Coastal Access Modification Report GAL-MR1

Proposed changes to the submitted England Coast Path proposals
for Gretna to Allonby

Location affected: **Burgh Marsh/Burgh-by-Sands, Cumbria**

9th May 2022

Map GAL-MR1a - Burgh Marsh/Burgh-by-Sands

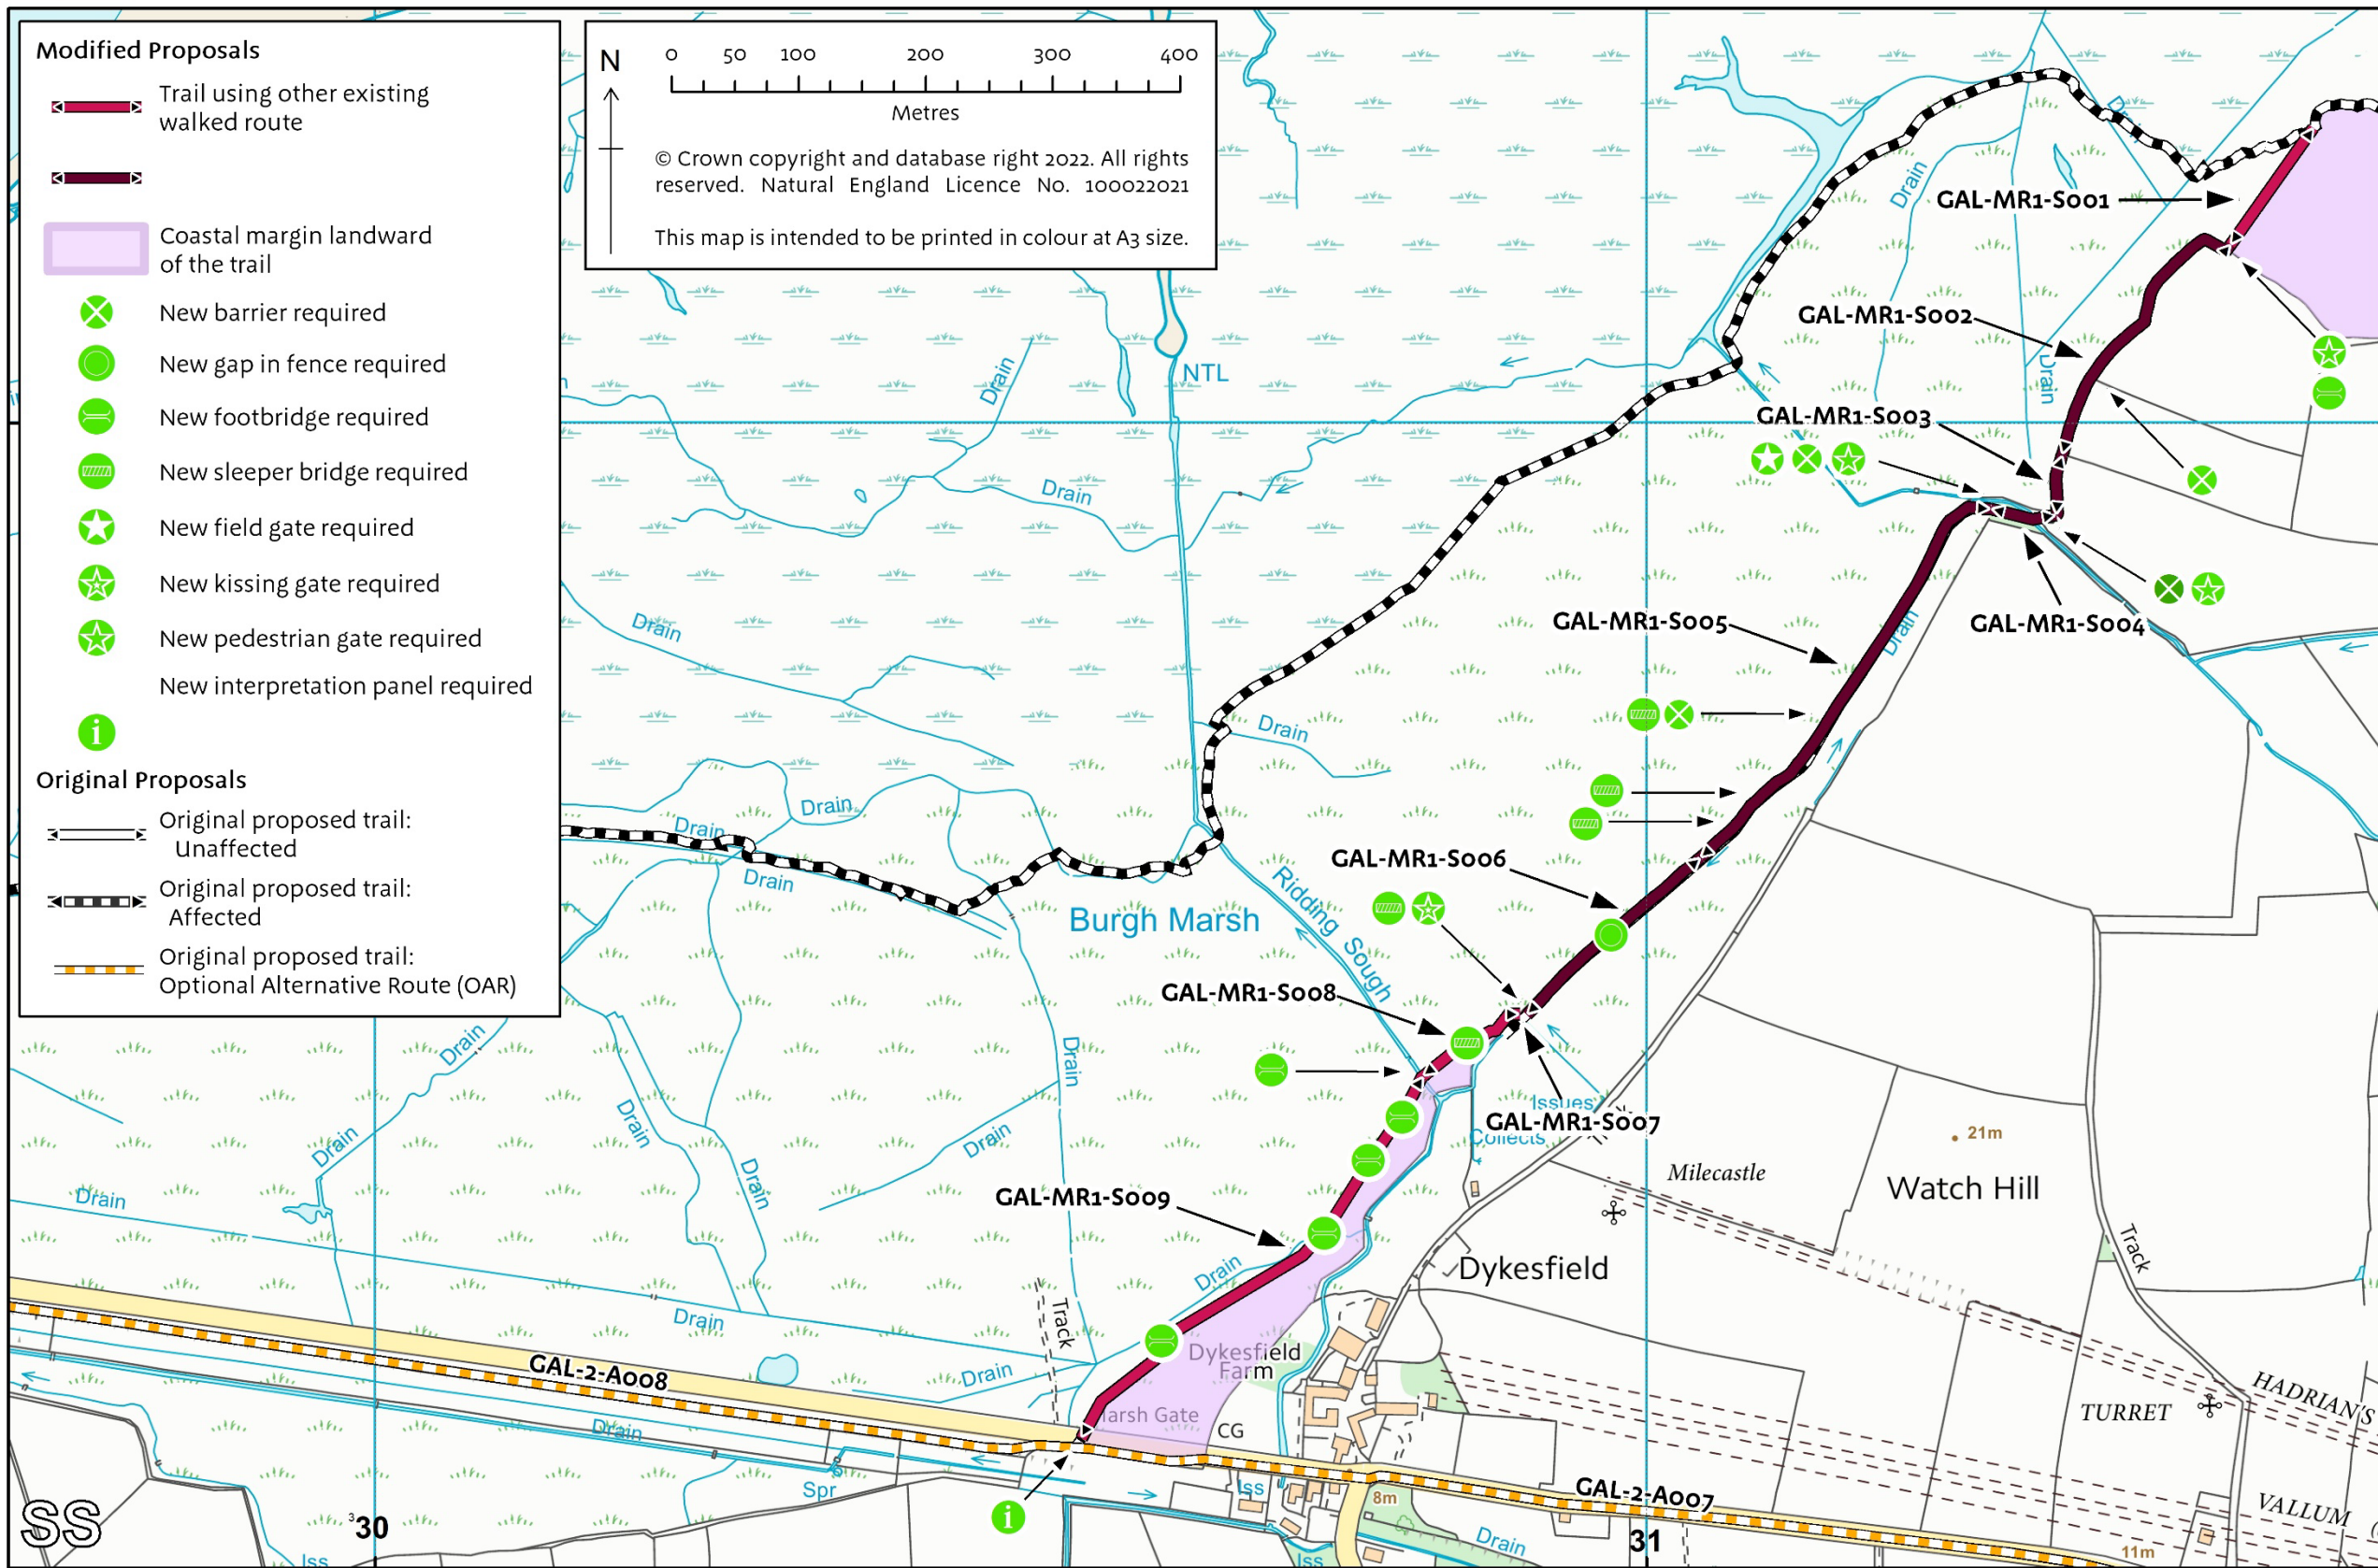
A.2.1 Our proposal (see maps GAL-MR1a to MR1c) is, from east to west, to re-route the path shown as the western end of GAL-2-S068 and all of GAL-2-S069 in our original report. The realigned trail would extend for an approximate length of 3,700 metres, at a maximum of 490 metres landward of the original route proposed.

A.2.2 The revised route would continue along the higher coastal grazing land west of the King Edward I monument, before leaving the marsh and following the seaward edge of agricultural land towards the road, just west of Dykesfield. From this point, the route would follow what was originally proposed as part of the optional alternative route, along the top of the flood embankment, just landward of the road, towards Drumburgh.

A.2.14 Column 4 of table A.3.1 indicates where roll-back has been proposed in relation to a modified route section. Where this is the case, the route, as initially determined at the time this modification report was prepared, is to be at the centre of the line shown on map GAL-MR1a as the proposed modified route of the trail.

Map GAL-MR1b - Burgh Marsh/Burgh-by-Sands

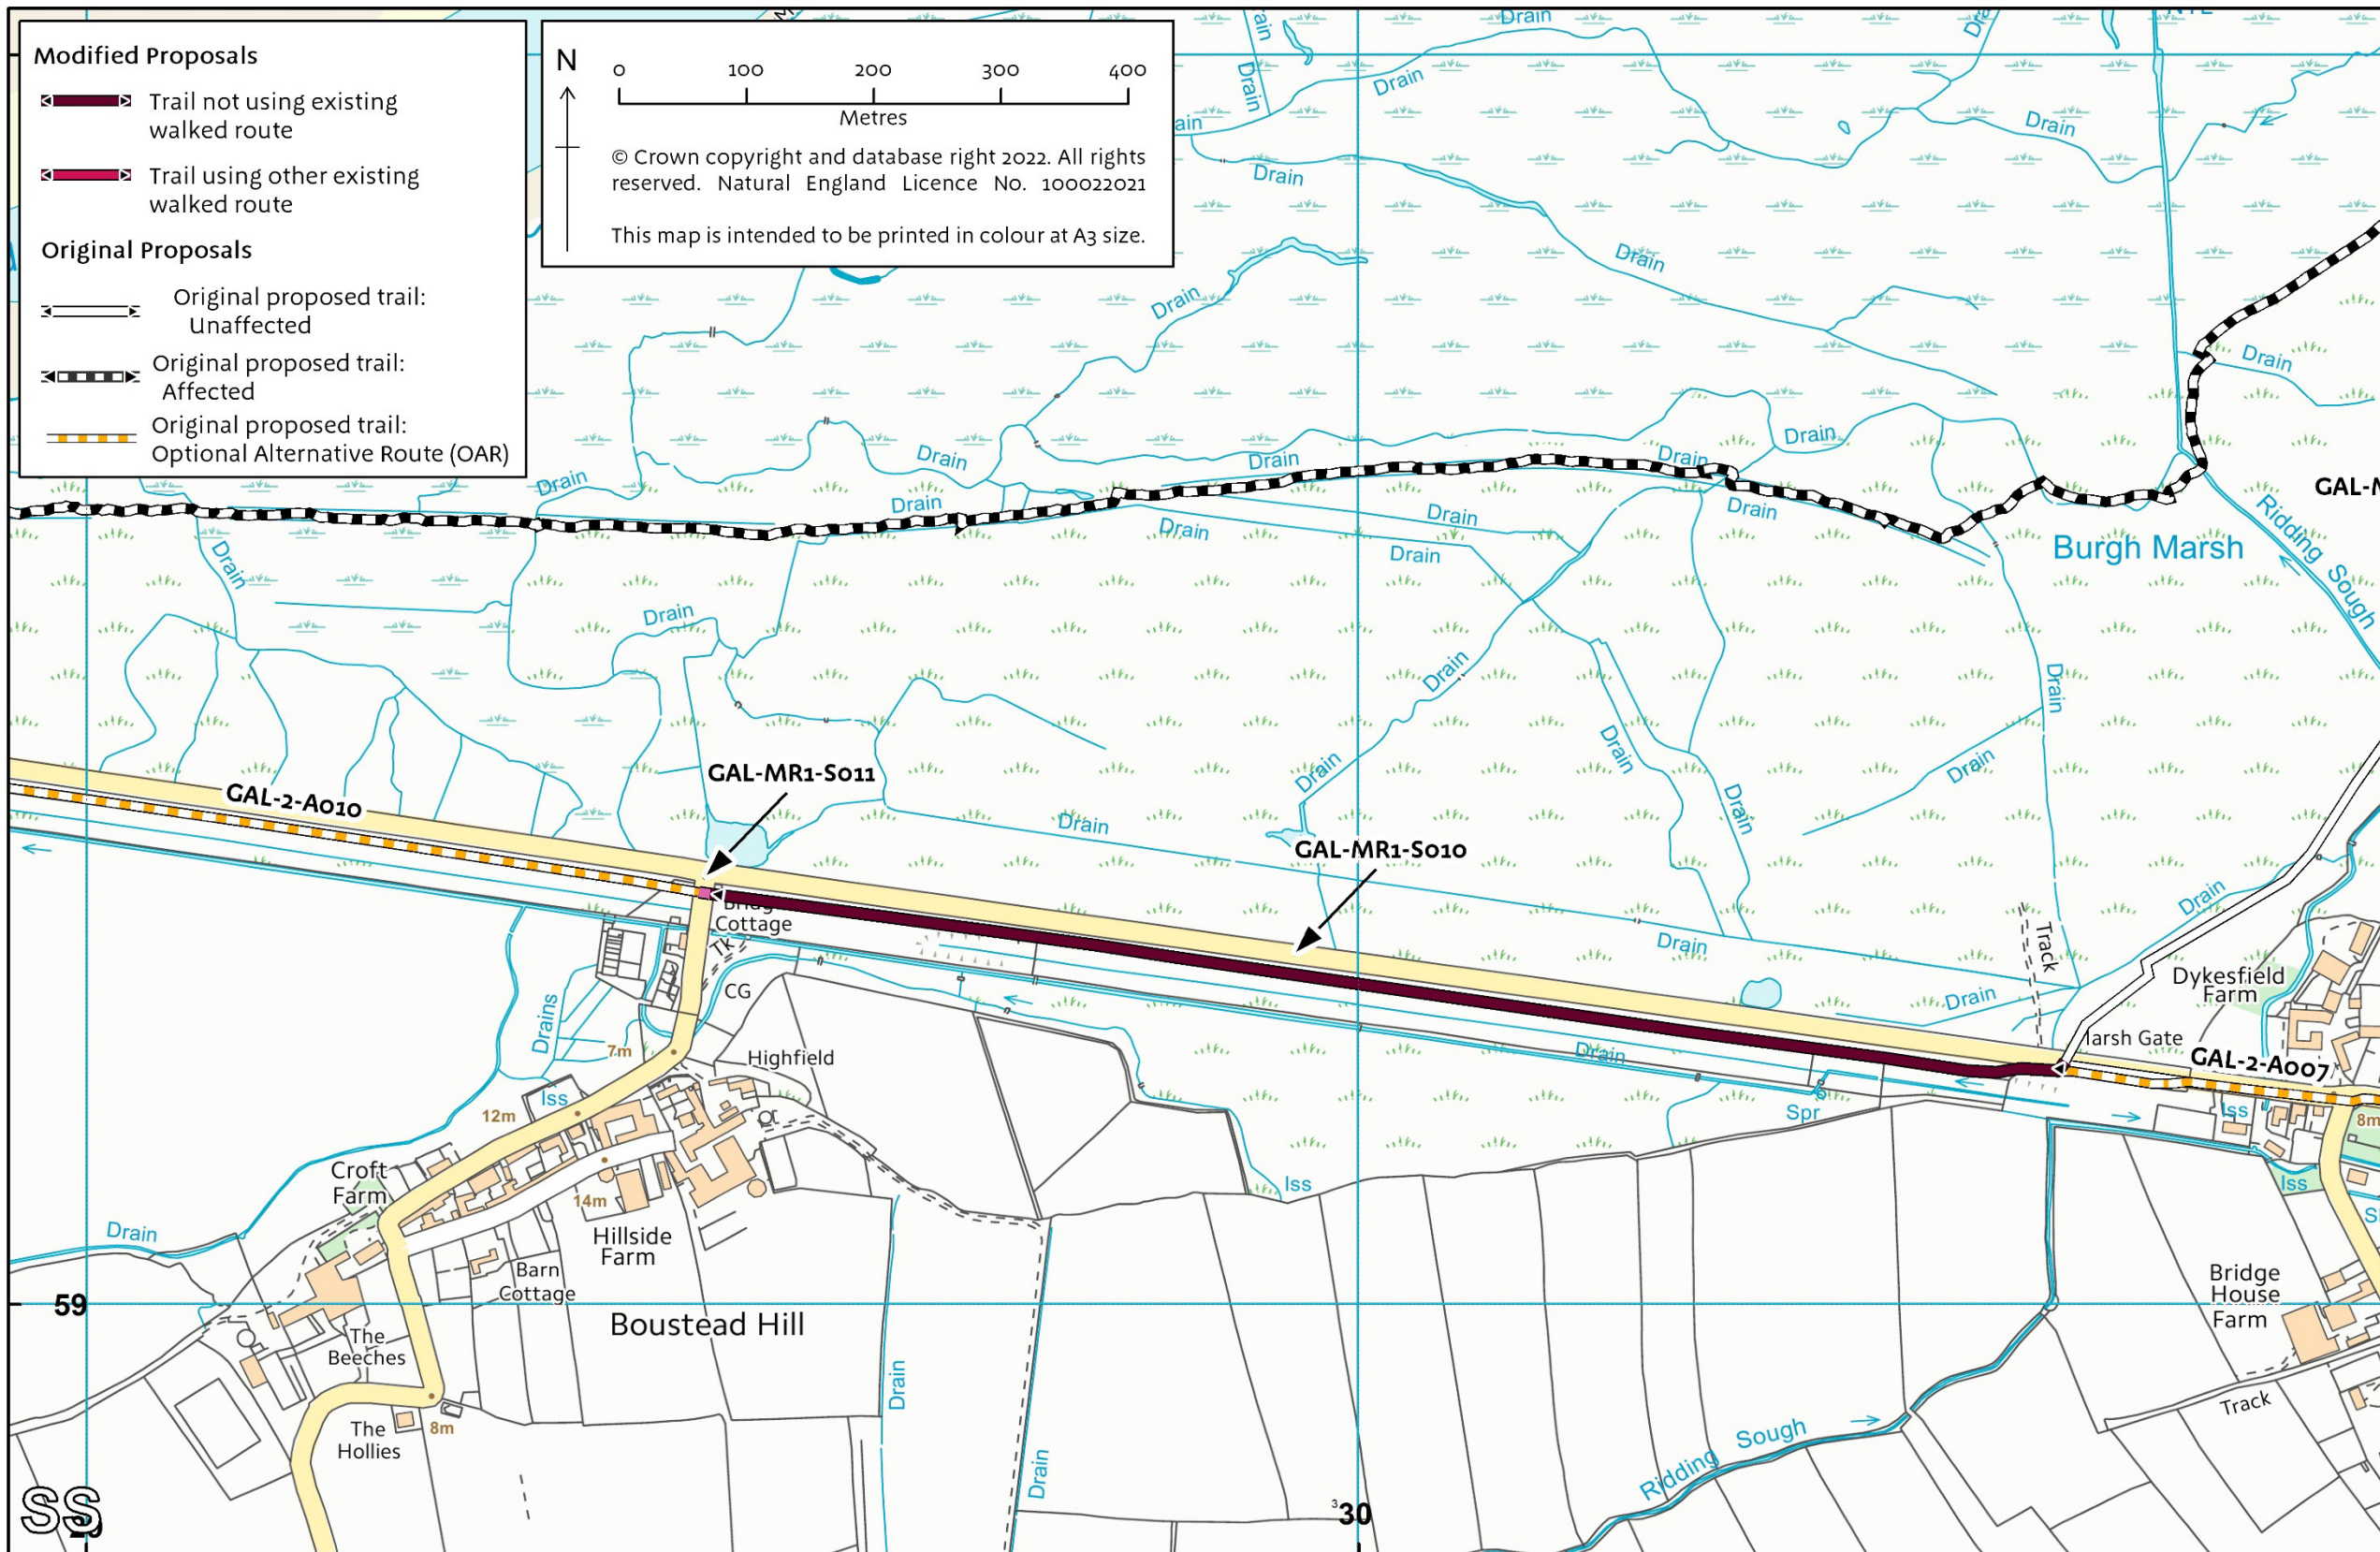
On sections for which roll-back is not proposed in table A.3.1, the modified route is to be at the centre of the line shown on maps GAL-MR1b and MR1c as the proposed route of the trail.
